ROOFING REPLACEMENT  
BEAVERTON SCHOOL DISTRICT  
NANCY RYLES ELEMENTARY SCHOOL

## PLAN CHECK COMMENT REVISIONS NO. 1 – Nancy Ryles Elementary

The Plan Check Comment Revisions forms a part of the Contract Documents and modifies the original documents for the Roofing Replacement Beaverton School District Nancy Ryles Elementary School – Bid/Permit Documents, dated 7/8/22 as noted below.

14 TYPICAL RAISED CURB  
SCALE: 3" = 1'-0"

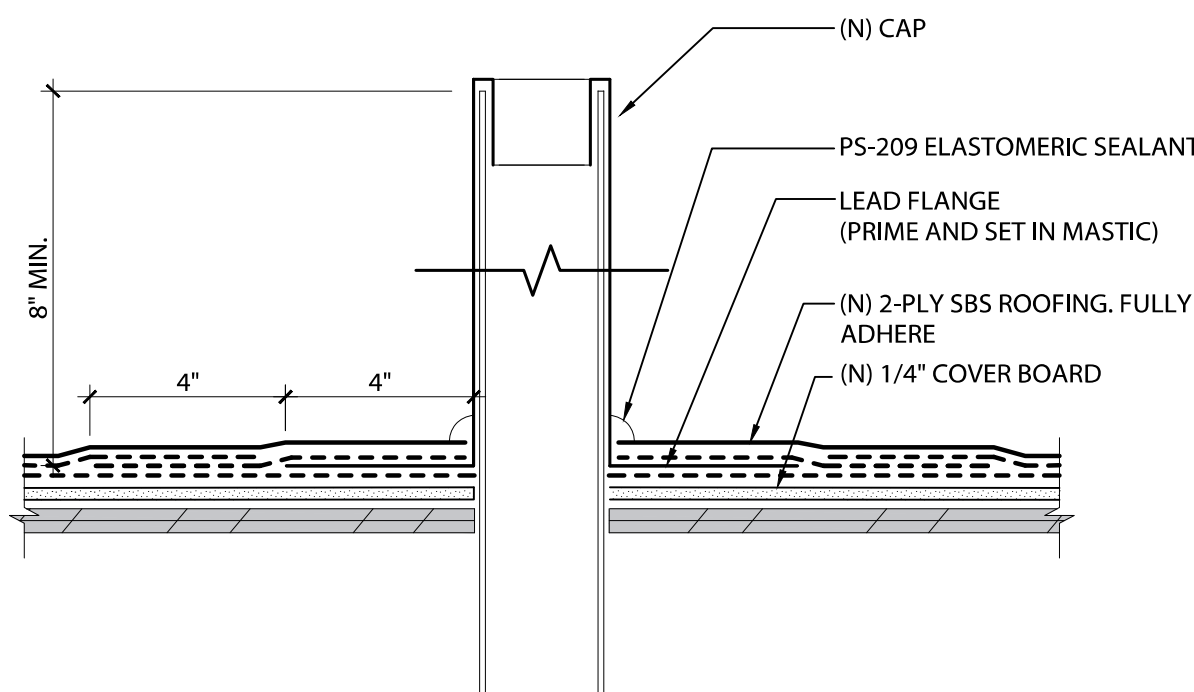
**P1.4**      **REFER TO:**                      **Sheet #; Name - Description**  
 CLARIFICATIONS:                      Sheet A-511; General Roof Assemblies and Typical Roof Details

- Clarification Note to Detail 14 Typical Raised Curb.

7 LADDER DETAIL

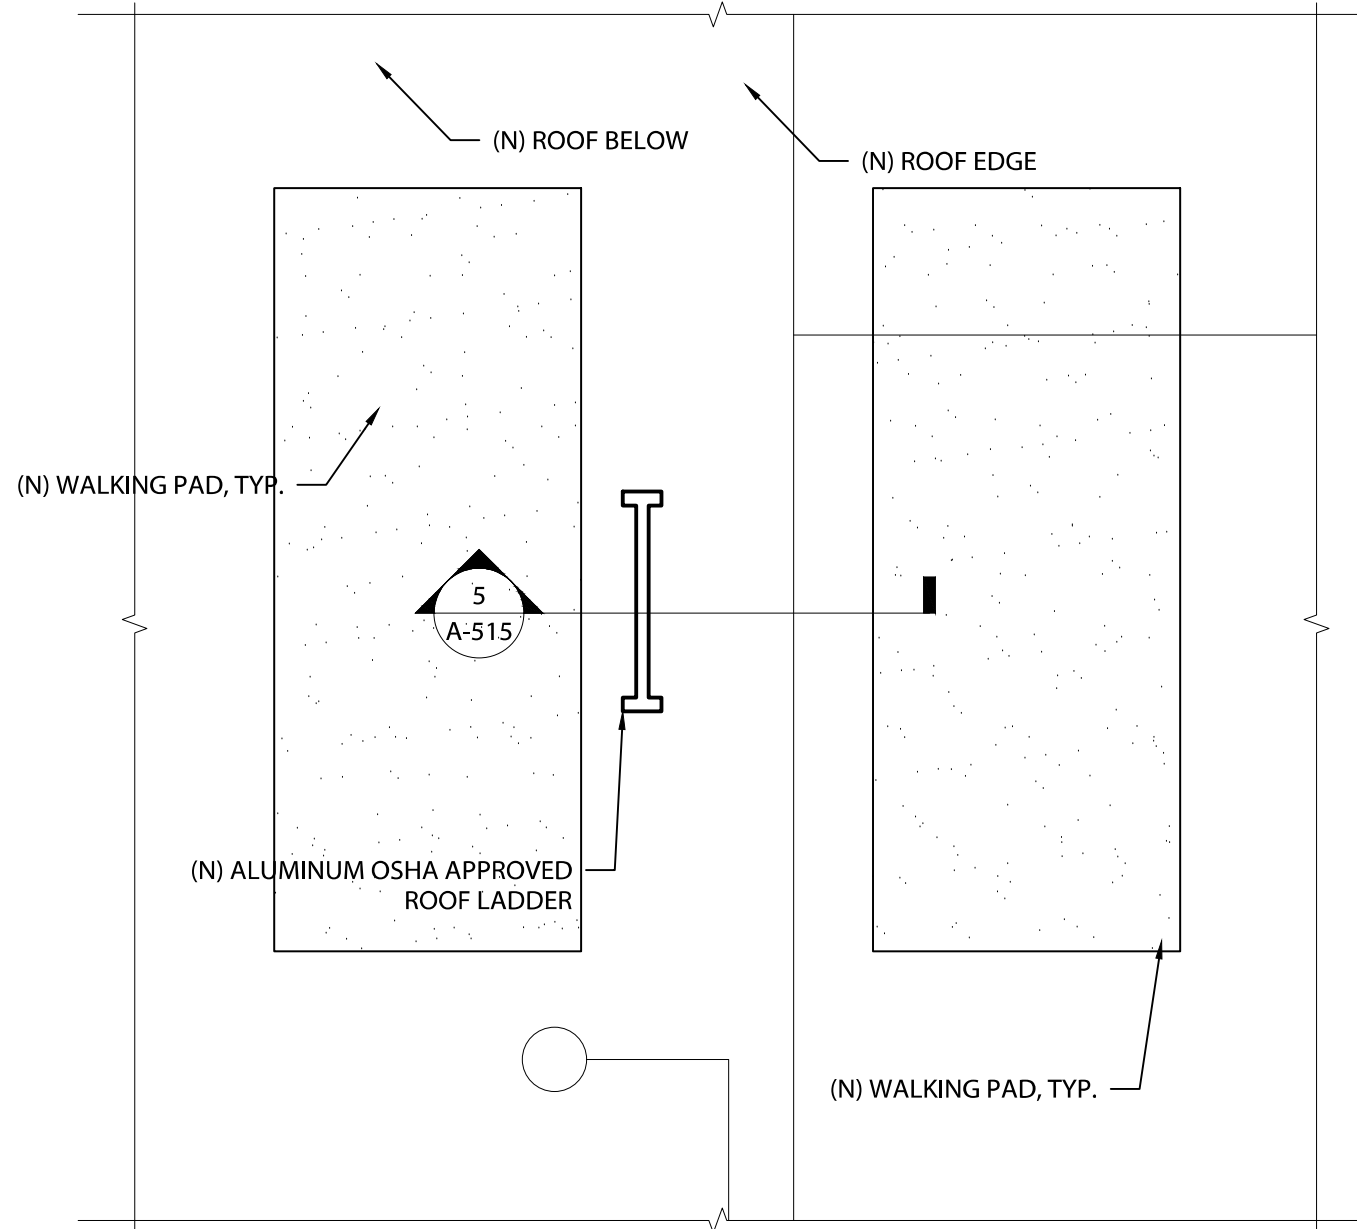
CLARIFICATIONS:                      Sheet A-515; Enlarged Plans and Details

- Clarification to Detail 2 Roof Hatch Side Elevation.
- Clarification to Detail 7 Ladder Detail.
